PIC18C658/858 Rev. B1 Silicon/Data Sheet Errata

The PIC18C658/858 parts you have received conform functionally to the Device Data Sheet (DS30475A), except for the anomalies described below.

FIGURE 1: PIC18CXX8 VOLTAGE-FREQUENCY GRAPH (INDUSTRIAL, EXTENDED)

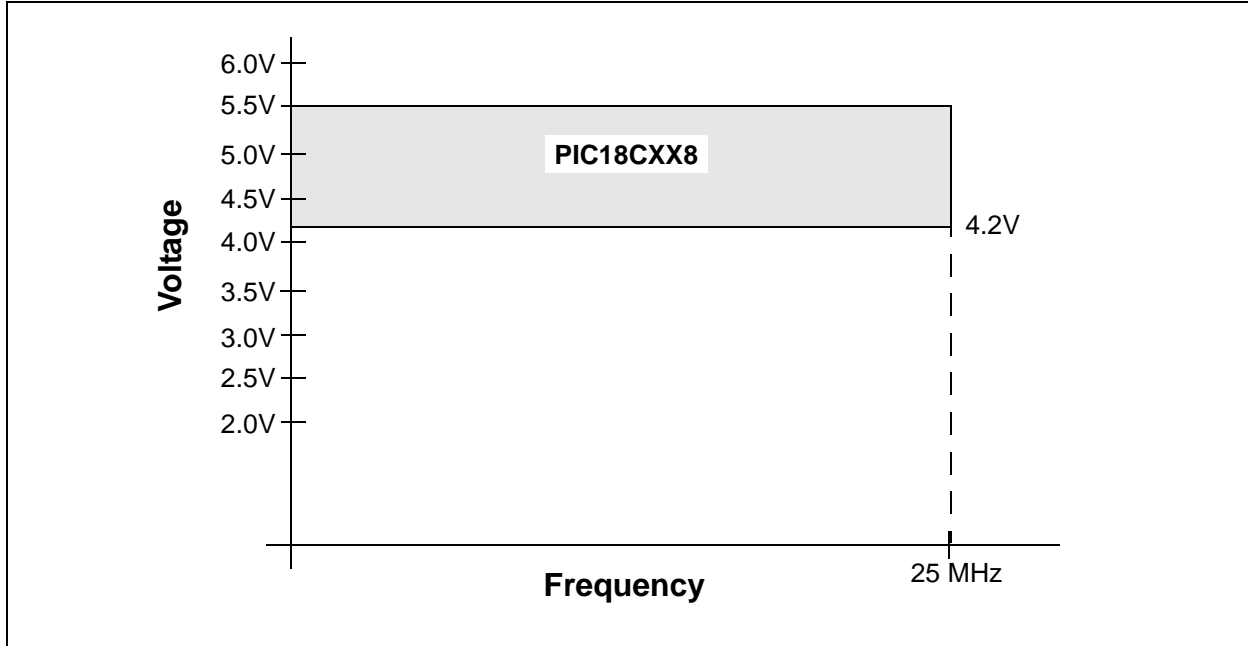
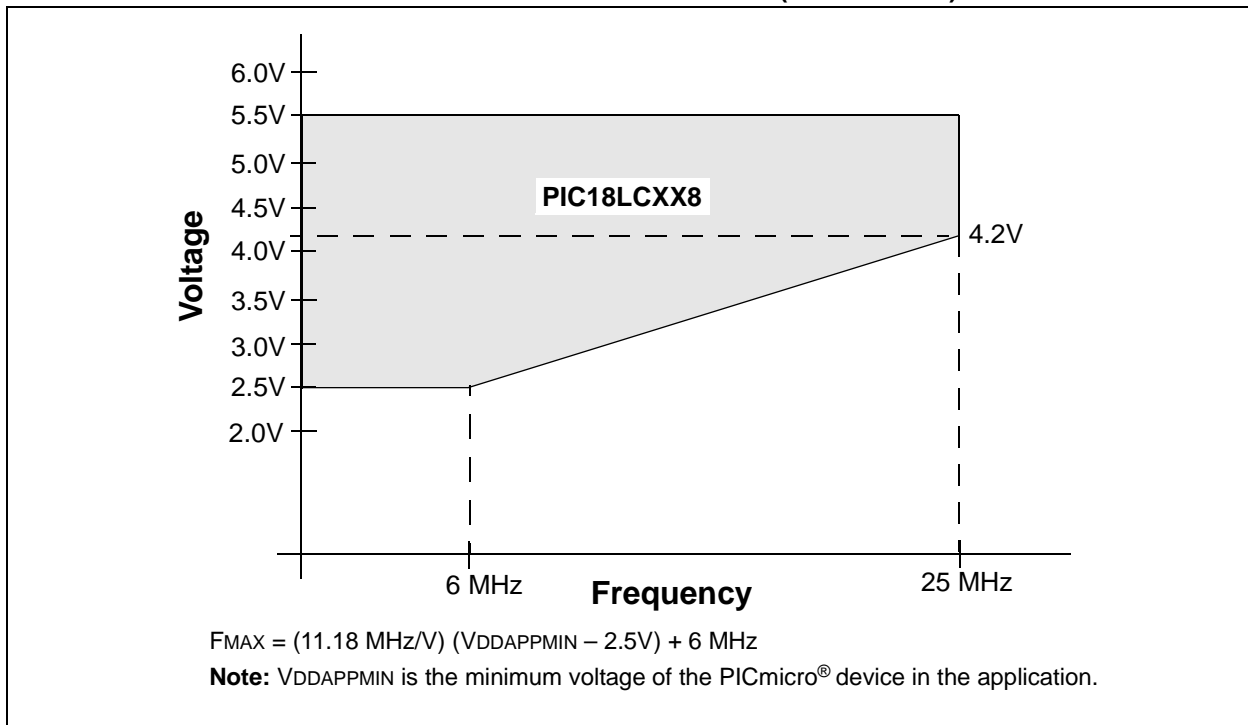
12. Module: Core (Voltage vs. Frequency)

The device may not operate properly at frequencies exceeding 25 MHz. The graphs in Figures 1 and 2 show the expected voltage vs. frequency operating range for standard voltage range and extended voltage range devices, respectively.

Work around

None. This issue is expected to be resolved in a future silicon revision. Please contact a Microchip sales office for additional information on availability.

FIGURE 1: INTERRUPT LOGIC (EXCERPT)

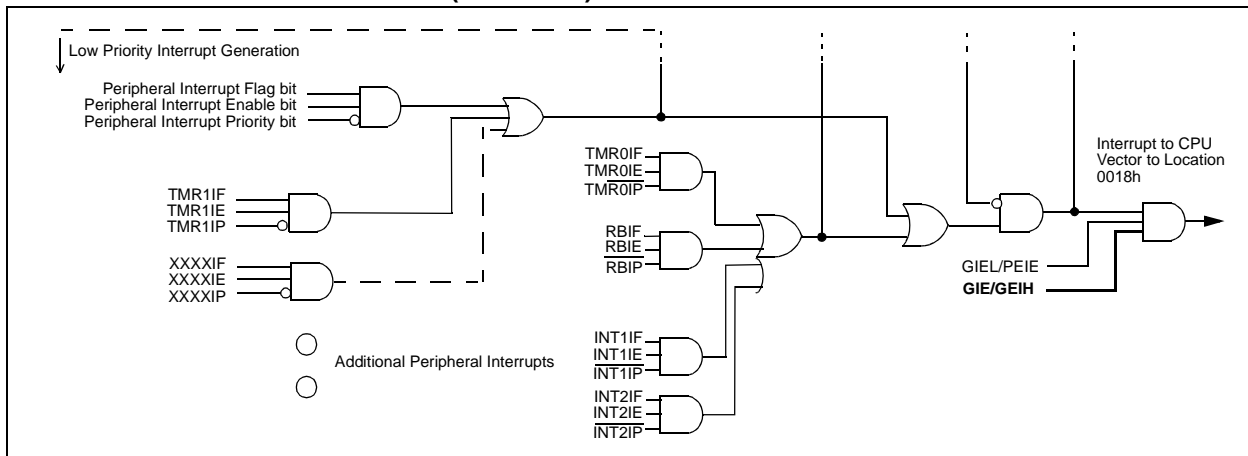
Also, the interrupt logic funnel shown in Figure 7-1 of the Device Data Sheet is amended with the addition of a GIE/GIEH control line, as shown in Figure 1 (new material in **bold line**).

The operation of the GIE/GIEH bit (INTCON<7>) is clarified as follows: when the bit is cleared, all interrupts are disabled. This is regardless of the state of the IPEN bit (RCON<7>), the priority of the interrupt, or whether or not the interrupt is unmasked. This varies from the original description, in which clearing the bit when IPEN = 1 would only disable high priority interrupts.

“It is important to note, however, that clearing the GIE/GIEH bit, regardless of the state of the IPEN bit, will disable **all** interrupts.”
